Packet Guide
City of Charlottesville
Board of Architectural Review
Regular Meeting
April 15, 2025 5:30 p.m.
Hybrid Meeting (In-person at Council Chamber and virtual via Zoom)

Recommendation for Special Exception Permits

Certificate of Appropriateness Application

Section 2.4.4 CX-8 Corridor Mixed Use 8: B.Building

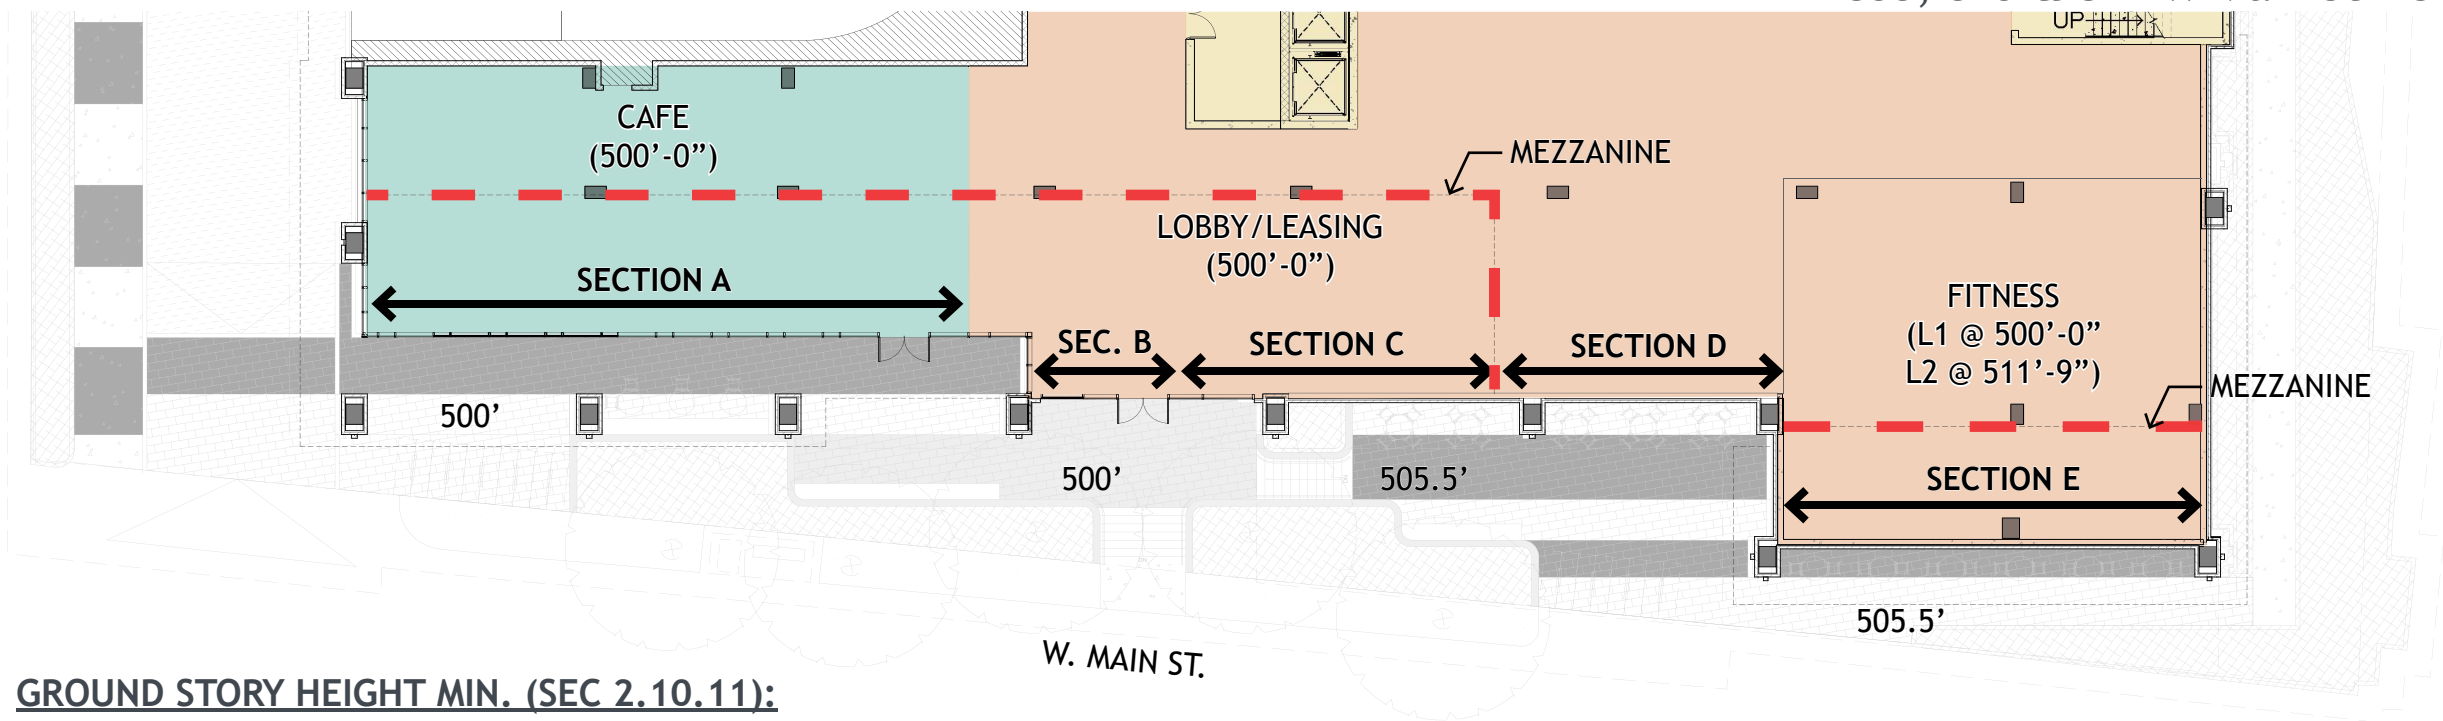
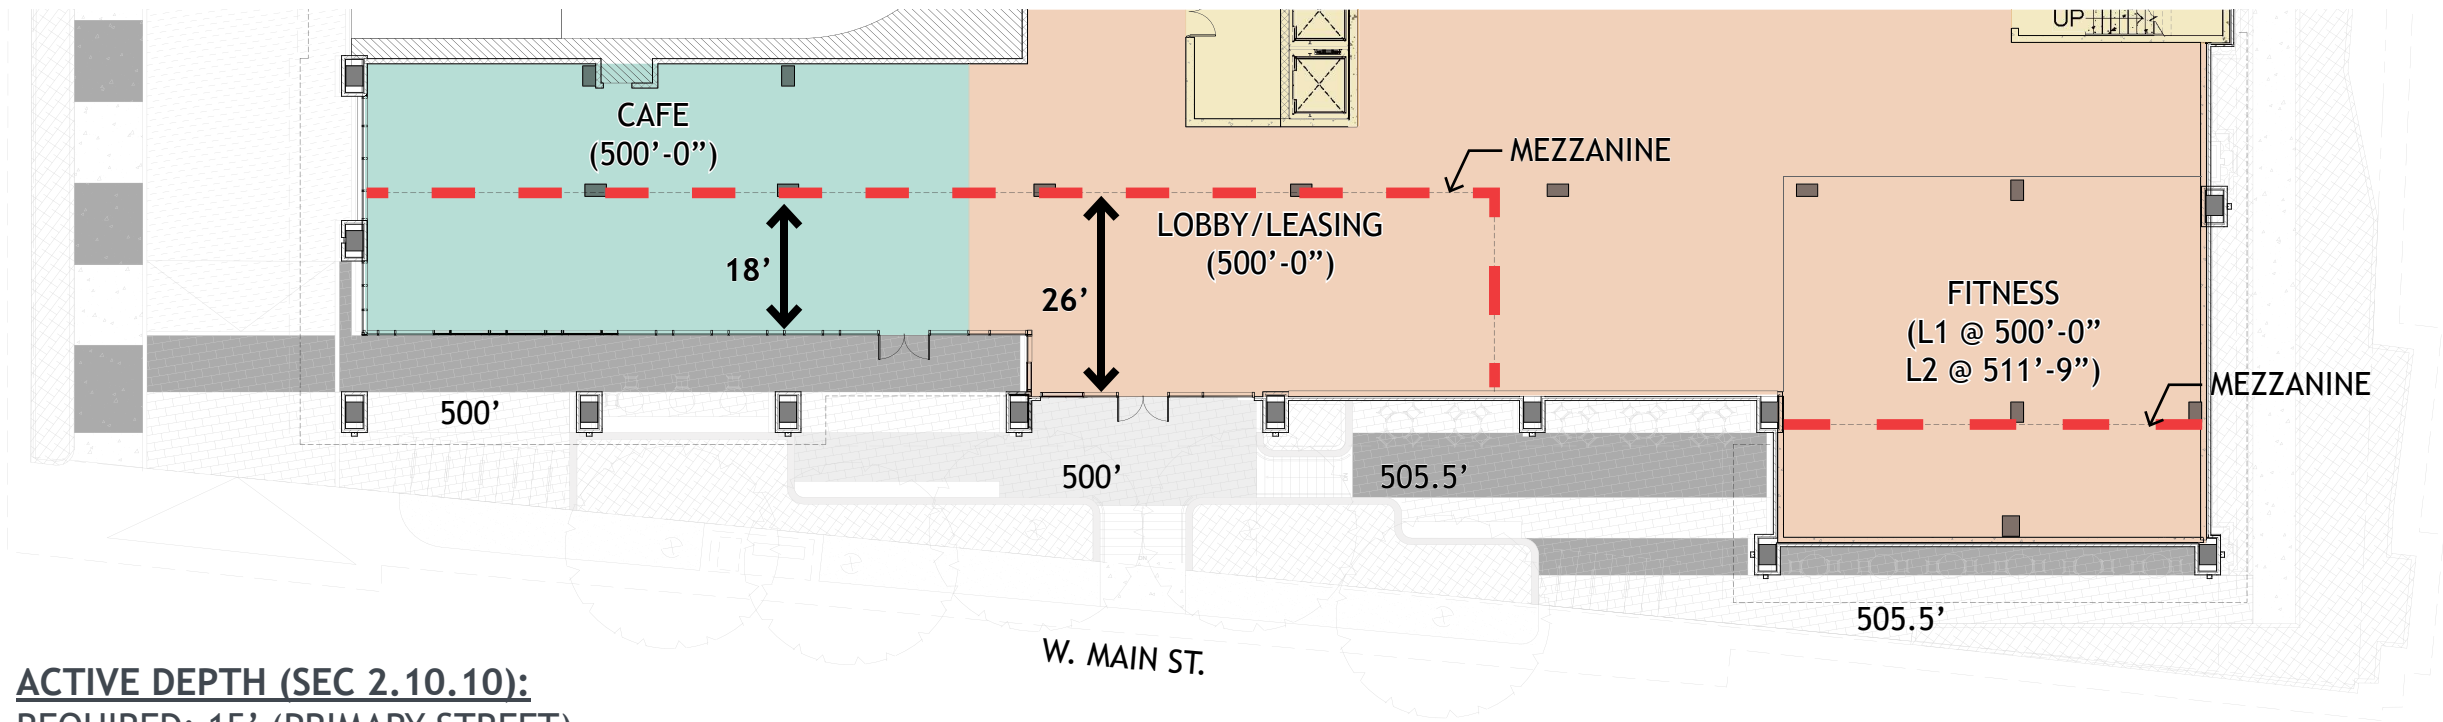
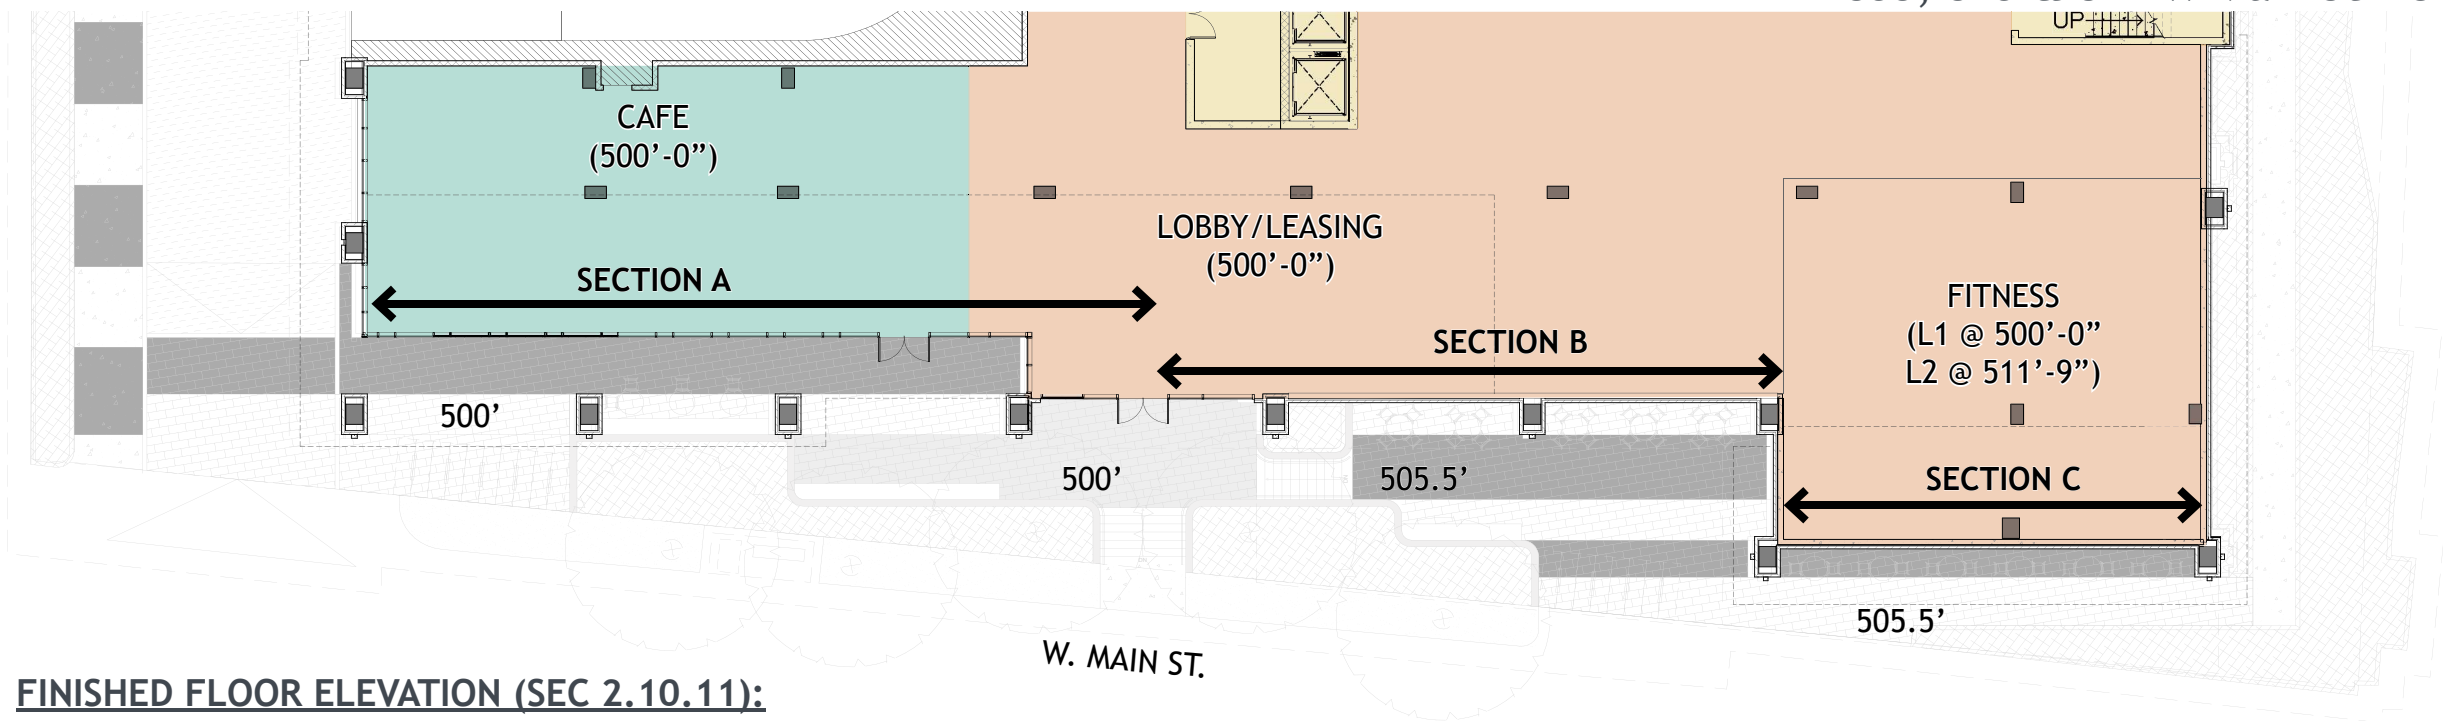
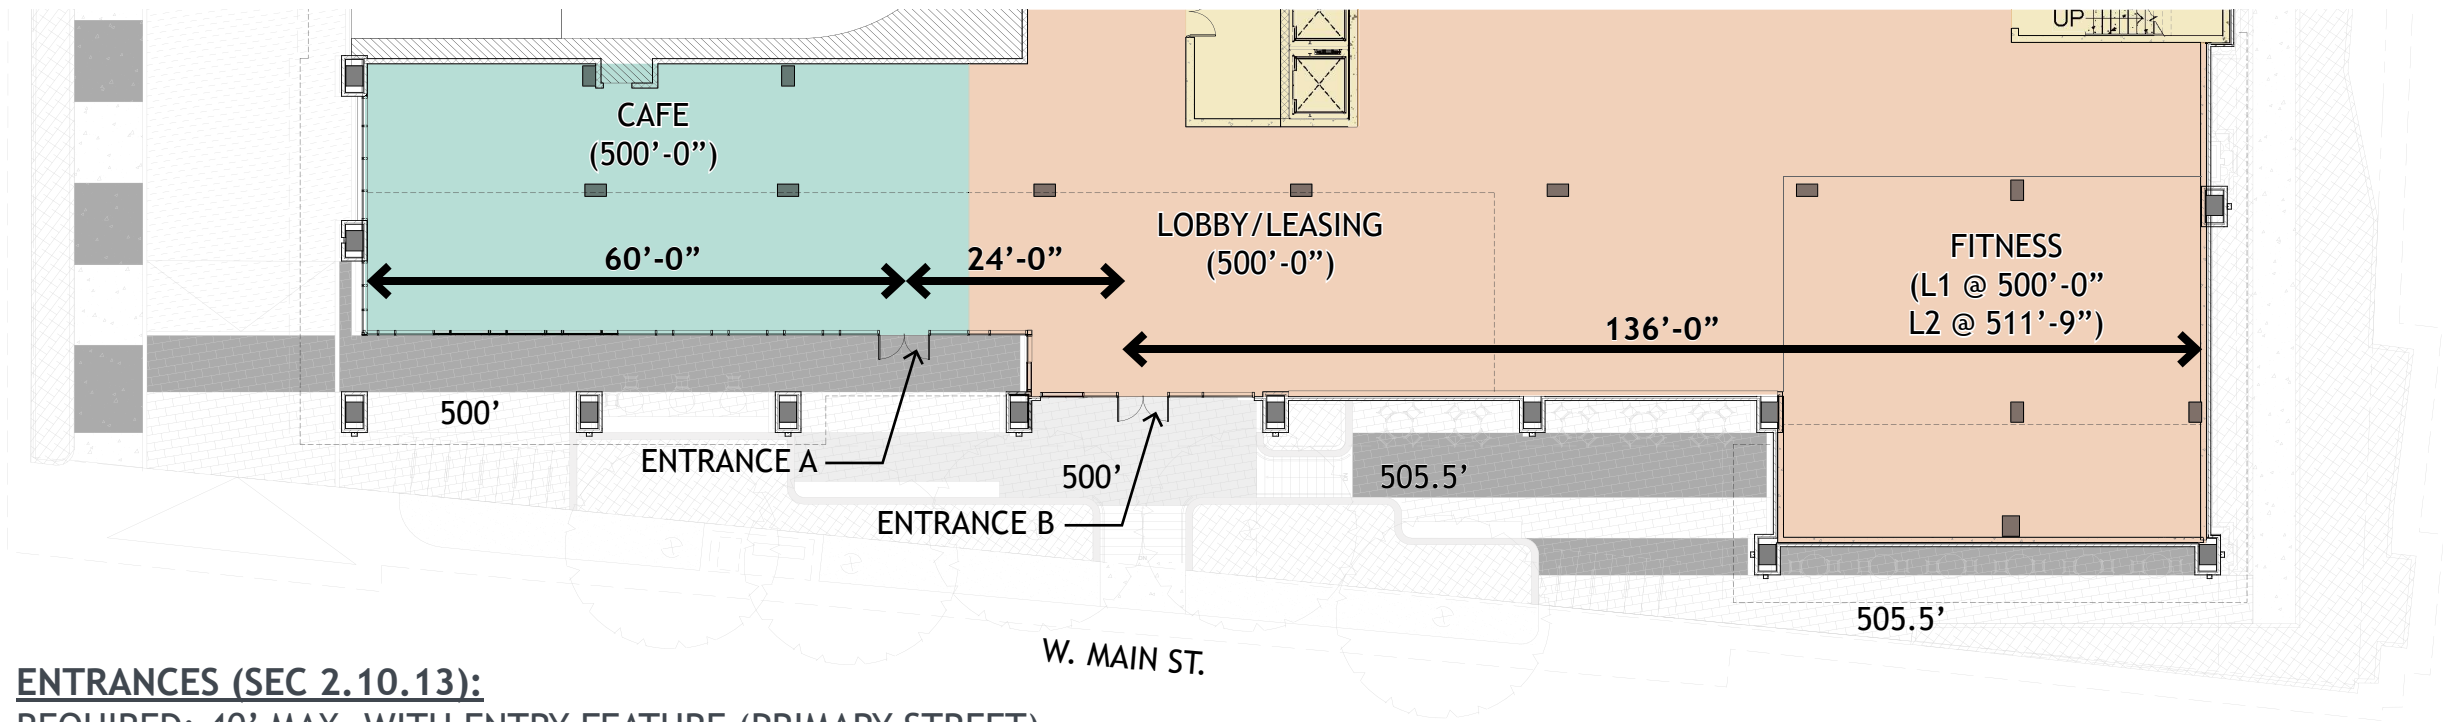
Per Section 2.4.2.B.3.F for non-residential spaces, the minimum ground floor height from finish grade is 14'. Due to existing grading conditions on the site, and to provide an accessible entry at level 1, the team requests an exception to the minimum ground floor height requirements for Section D as shown in Appendix A.1.

As indicated in Appendix A.1, the floor-to-floor height is 6'-3" from grade to level 2 at Section D due to the grade stepping up from 500' to 505.5' at the plan southeast corner. Section A, B, C and E meet the minimum ground floor height requirements as shown in Appendix A.1. Level 2 is proposed to extend Section D only to provide access to the amenity space on this level.

Per Section 2.4.2.B.5, street facing entry spacing shall be 40' maximum on primary streets. The team is requesting an exception to the entry spacing, as indicated in Appendix A.2, due to the existing grading conditions and the need to provide accessible entrances into the building from the public plaza.

Finding of no adverse impact: Based on the information provide and addressing only the three items subject to a Special Exception Permit that are related to the exterior of the proposed multi-story building at 835-853 West Main and therefore the only items germane to the BAR's purview, I move the BAR recommend to City Council that granting the requested Special Exception Permits for these three items will not adversely impact this property or the West Main ADC District. Furthermore, these items were represented in the building design reviewed by the BAR on June 16, 2026, for which a Certificate of Appropriateness was approved.
